CITY OF ALBUQUERQUE

July 22, 2024

**RE: Fuentes Auto Sales
700 Gibson Blvd. SE
Grading & Drainage Plan
Engineer's Stamp Date: 7/12/2024
Hydrology File: L14D010**

PROJECT NO: 24035
DESIGNED BY: RJF
DRAWN BY: JB
CHECKED BY: RJF
DATE: JULY 2024
SHEET TITLE
GRADING PLAN
SHEET NO: **C-1**

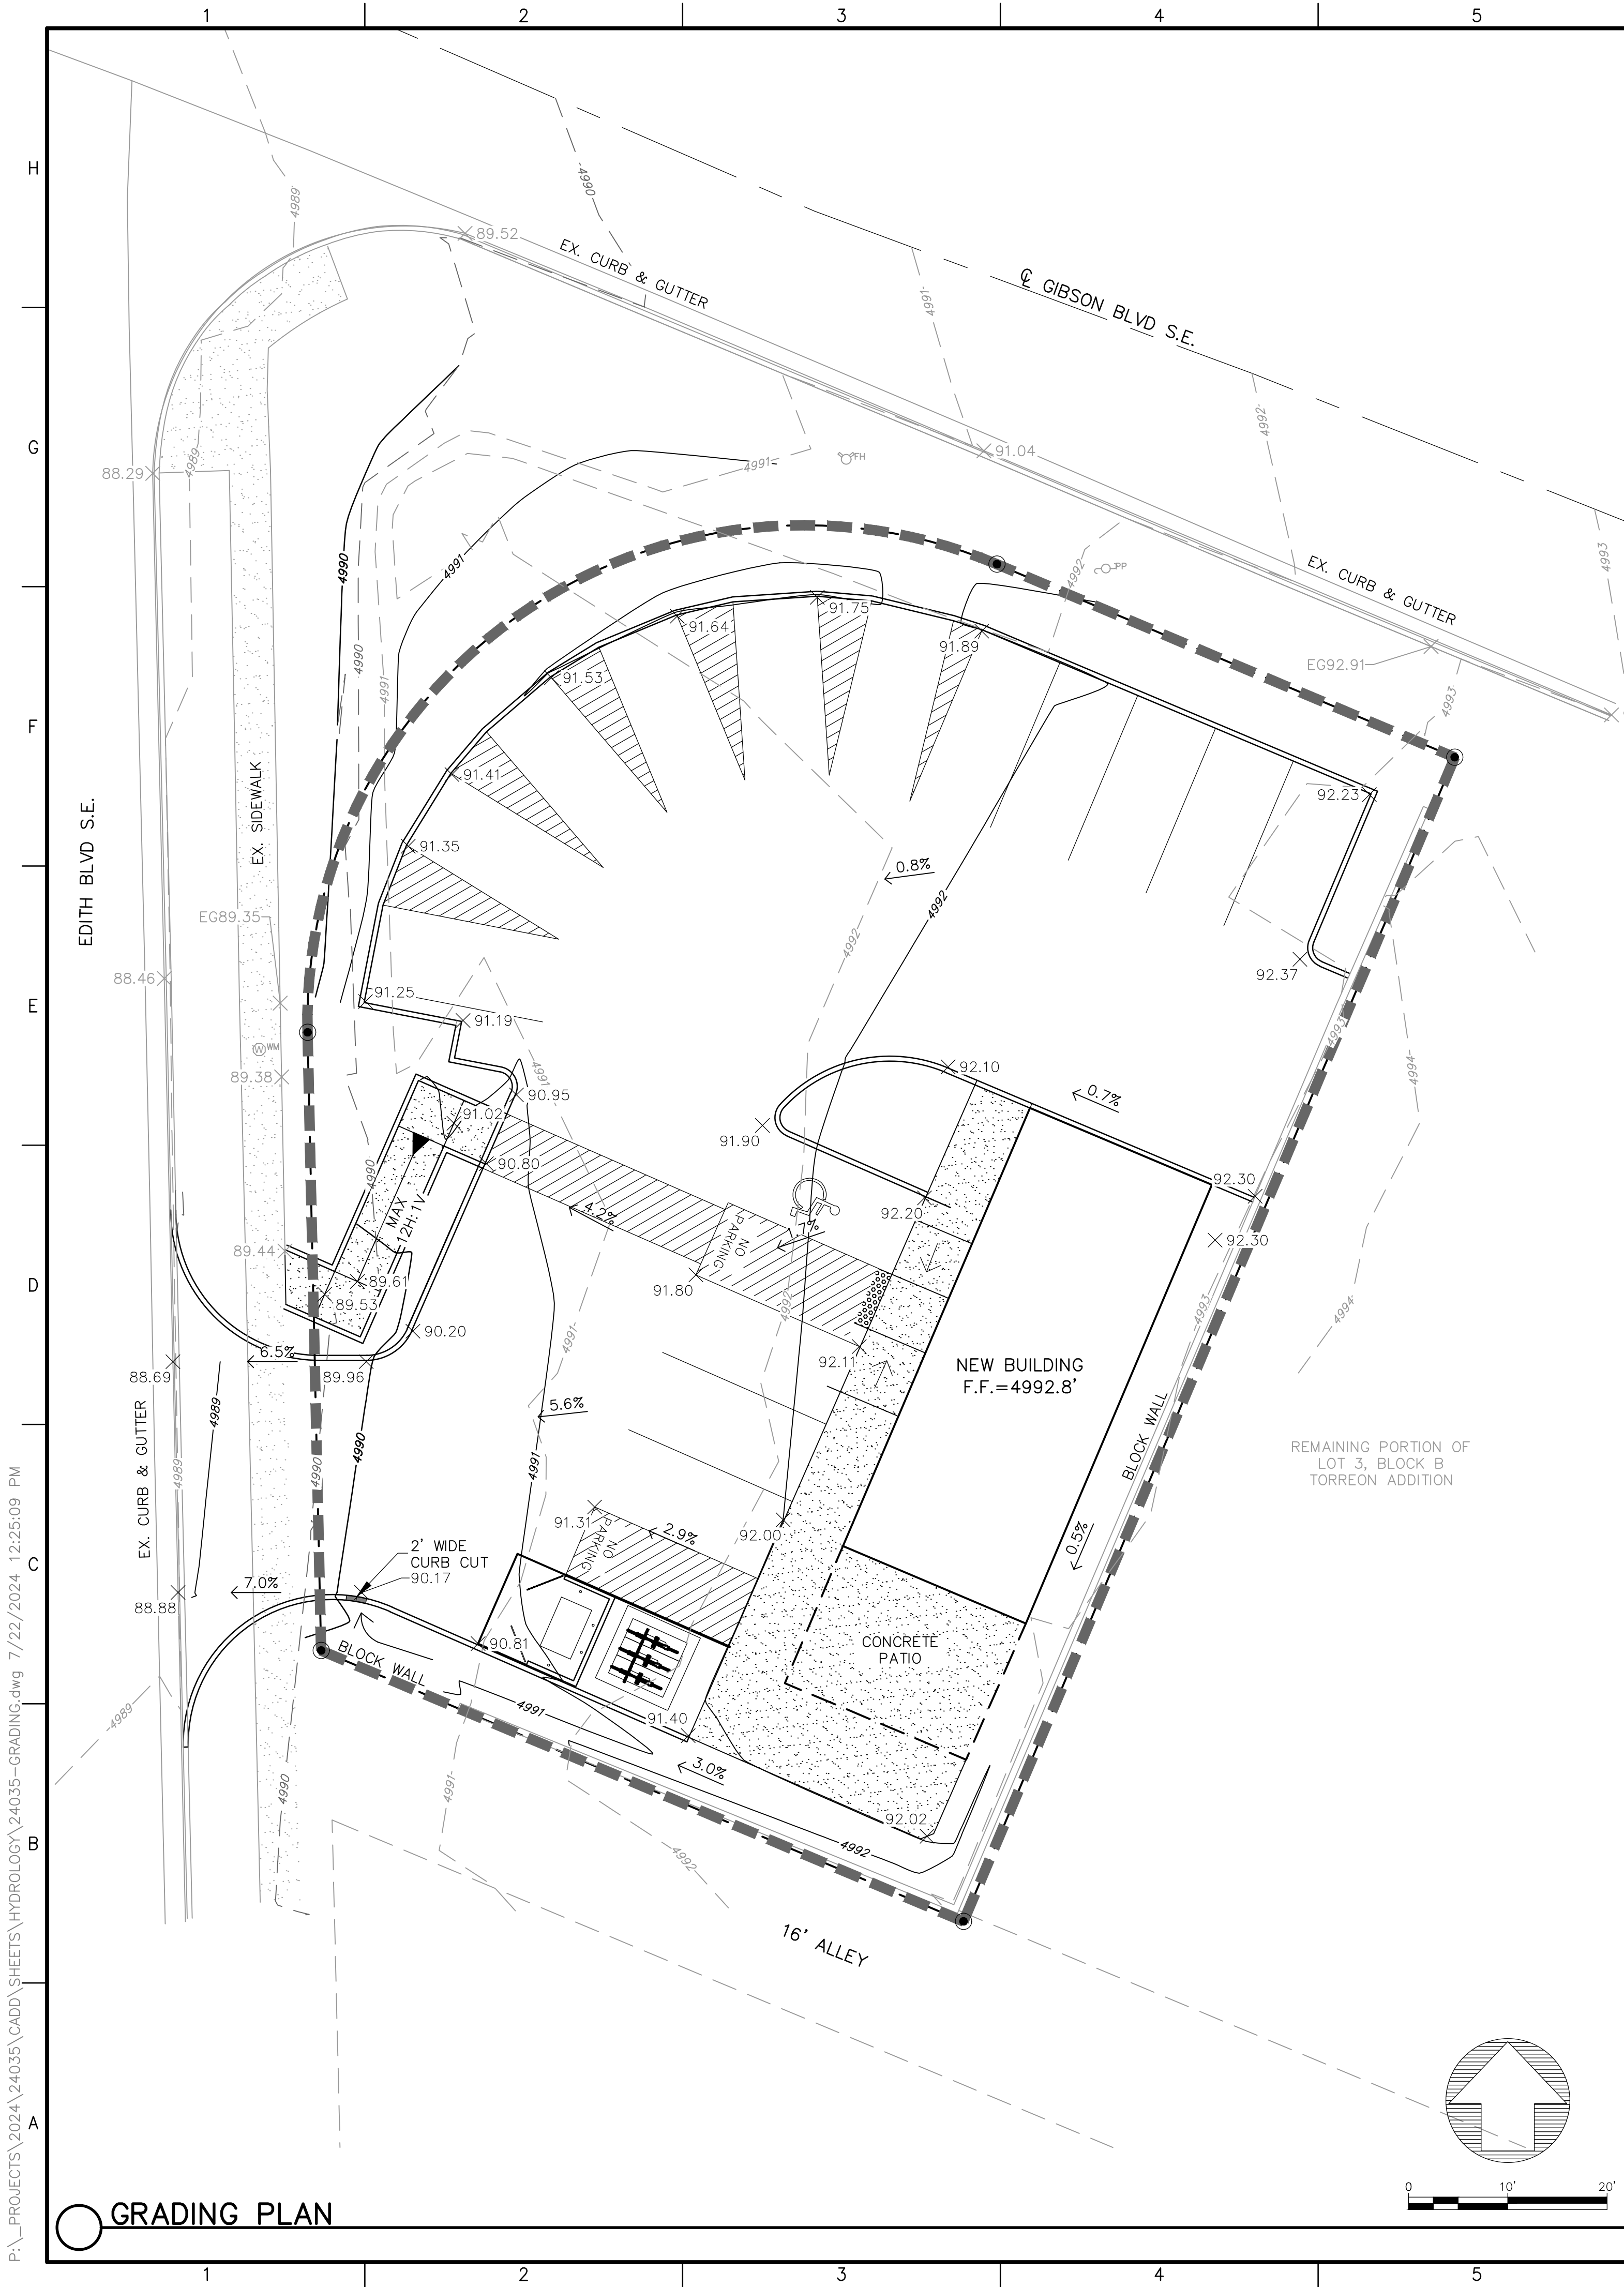
Based upon the information provided in your submittal received 07/12/2024, the Grading Plan is approved for Grading Permit. Please attach a copy of this approved plan in the construction sets for Grading Permit processing along with a copy of this letter.

1. Engineer's Certification, per the DPM Part 6-14 (F): *Engineer's Certification Checklist For Non-Subdivision* is required.
2. Please pay the Payment-in-Lieu of \$ **1,552.00** by emailing the attached approved Waiver Application from Stormwater Quality Volume Management On-site to PLNDRS@cabq.gov. Once this is received, a receipt will then be produced and email back. Follow the instructions on the bottom of the form and pay it at the Treasury in Plaza de Sol. Once paid, please provide me proof of payment.
